Upstate Central Chilled Water Plant Chiller #3 Replacement University of South Carolina - Upstate

SC State Project # H34-9545-JM

Addendum No. 2

DATE: December 3, 2015

UPSTATE CENTRAL	CHILLED WATER PLAN			
CHILLER #3 REPLACEMENT				
SPARTANBURG, SOL	JTH CAROLINA			
VDDENDIIM #3 (DB	AWING NO MD 1)

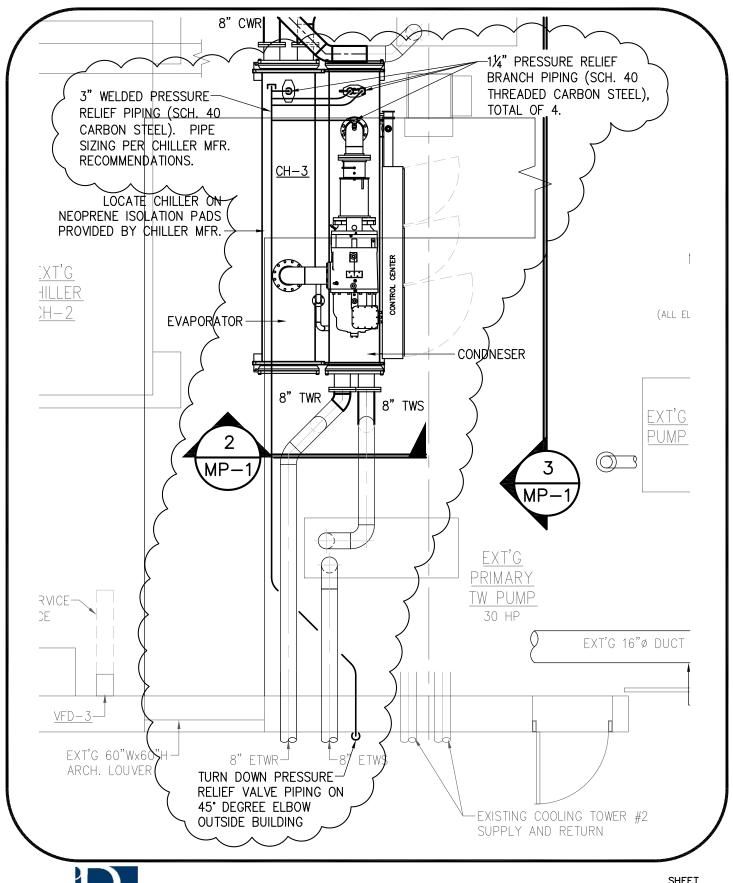
- 1. Drawing E-1, Renovation Note 1 "New Chiller #3", first sentence, delete "three #500 MCM THHN copper conductors with one #2 AWG copper green insulated ground wire" and replace with "six #4/0 AWG THHN copper conductors with one #2 AWG copper green insulated ground wire".
- 2. Drawing E-1, Detail 3, Existing Switchboard Elevation, ADD the following note "It is required to provide double-barrel lugs on the load-side of the new 500 amp rated circuit breaker that will accept two #4/0 AWG copper conductors per phase.
- 3. See Mechanical Piping bulletin SKMP-1 for clouded revision to Drawing MP-1 adding pressure relief vent piping required for new chiller CH-3.
